TOLEDO - LUCAS COUNTY PLAN COMMISSIONS

REF: SUP-12003-22

SUBJECT: Amendment to a Special Use Permit Originally Granted by Ordinance 524-85, and Ordinance 852-86 for the raze and rebuild of a gas station and canopy at 950 W Alexis Rd.

SITE PLAN

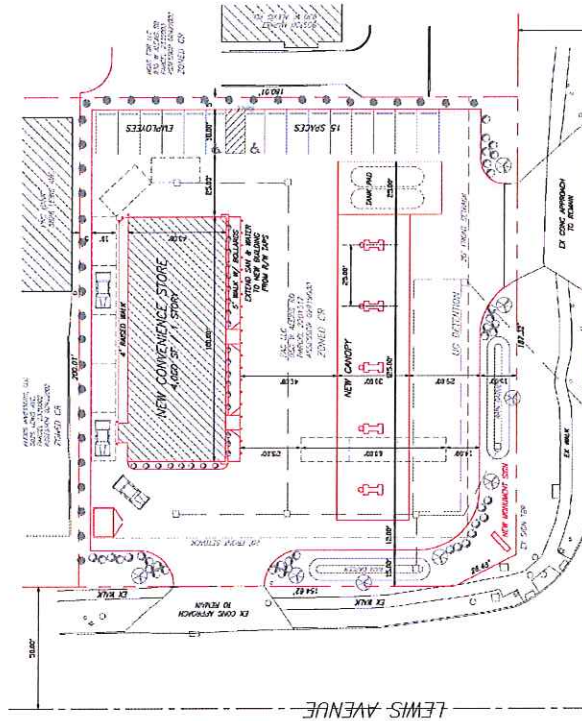
The site is required to have a minimum of one (1) stacking space per gasoline pump island, which have been provided. The drive-thru is required to have seven (7) stacking spaces per TMC§1107.1601 – *Vehicle Stacking Area*. The site plan provides the appropriate quantity of stacking. Bicycle parking is required at a rate of one (1) per ten parking spaces. None are shown and shall be required on a revised site plan.

The site is required to provide safe flow per pedestrian use per 1109.0204. A revised site plan shall be required to depict at least one walkway connecting the sidewalk going along either Alexis or Lewis to the front door of the building.

17. Existing water service lines to structures removed from the site will be abandoned by the City of Toledo at the developer's expense.
18. Sheet C1:
 - a. Under General Notes, #2 references Division of Engineering/Services in two locations. Please refer to the new division, Engineering and Construction Management.

- b. GIS shows a 1" possible lead service to the site. No tap card was able to be located. If the existing service is lead, that service will need to be abandoned and a new service installed by the City of Toledo at the Developer's expense.

27. Bicycle parking is required per TMC 1107.0900.
28. Pedestrian Crossing is required from the accessible parking loading area to the building sidewalk per TMC 1107.1602.

33. Litter receptacles for the use of parking area users and others, must be provided in off-street parking areas per TMC§1107.1910.
34. Pedestrian connectivity from the sidewalk on Alexis or Lewis shall be provided to the primary entrance.

LANDSCAPE PLAN

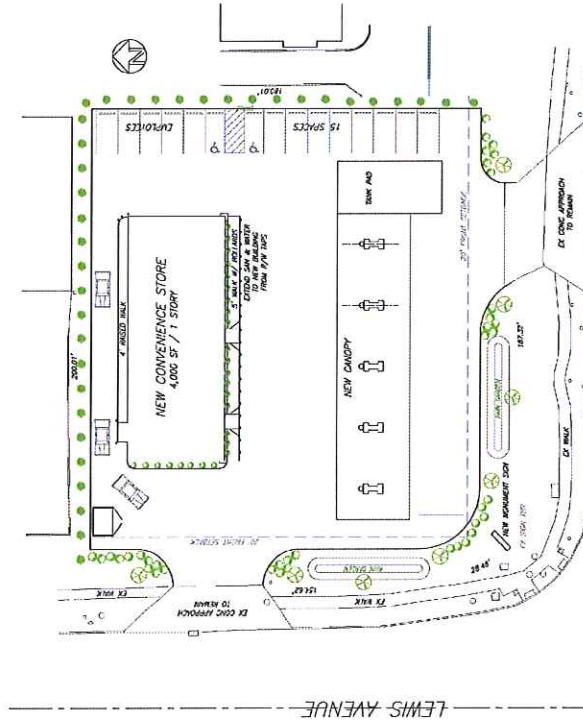
Pursuant to TMC§1108.0202 – *Frontage Greenbelt*, the site is required to have a fifteen-foot (15') planted landscape buffer along all street frontages. The buffer must contain at least one (1) tree for every thirty feet (30') of frontage. When a parking lot is proposed along the frontage greenbelt, there shall also be a solid evergreen hedge to screen the parking lot so that no headlights of any vehicles can be seen from the public street. A greenbelt is provided along Alexis and Lewis: as depicted it does not include all required plantings. In order to meet the requirement of one tree for every 30 feet (30') of frontage, seven (7) total trees shall be required along Alexis Road (four (4) are shown), and six (6) total trees along Lewis Avenue (four (4) are shown). A continuous line of shrubs is provided along the site, however gaps exist where the proposed rain gardens are located. The shrub line shall be required to be brought all the way along the parking area, and cannot be located within the rain garden. Corrections shall be shown on a revised landscape plan.

landscaping meets this requirement. Landscape terminal islands must be provided at the end of each parking row, none are depicted and shall be required in a revised landscape plan. Additionally, two (2) canopy trees and six (6) shrubs are required to be installed in interior landscape areas for each ten (10) parking spaces. A total of seven (7) trees and twenty-one (21) shrubs are required in the interior, which have been provided in the landscape plan.

Two (2) rain gardens are proposed within the frontage greenbelt. Said rain gardens may occupy up to 50% of the actual available greenspace, and are permissible as depicted. The stormwater treatment facility must be planted and landscaped, and may not reduce the other landscaping requirements provided within the TMC. The rain gardens must be planted with turf, trees, and/or perennial plant materials chosen from lists provided by the Rain Garden Initiative. The design of said rain gardens must be approved by the Department of Public Utilities. A revised landscape plan depicting the plantings within the rain gardens shall be submitted to the Plan Director for approval.

- a. A fifteen (15') foot landscape buffer along Lewis is required containing six (6) trees. **Not acceptable as depicted, additional trees required.**

- b. A fifteen (15') foot landscape buffer along Alexis is required containing seven (7) trees. **Not acceptable as depicted, additional trees required.**

- c. Perimeter landscaping is required around the parking lot to screen headlights from right of way. Additional shrubs stretching the entire length of the paved area along Lewis and Alexis are required. **Not acceptable as depicted.**

- f. Landscape islands/peninsulas are required at the end of each parking row. **None depicted, not acceptable as depicted.**
 - g. Landscape areas within the parking area must be peninsular or island types and must be constructed with six-inch (6") by eighteen-inch (18") concrete curbing, cast-in-place, extruded, or by some other process approved by the Planning Director;

- t. A detailed planting plan for the proposed rain gardens is required. The rain gardens must be planted with turf, trees, and/or perennial plant materials chosen from lists provided by the Rain Garden Initiative. The design of said rain gardens must be approved by the Department of Public Utilities. **No planting plan submitted.**
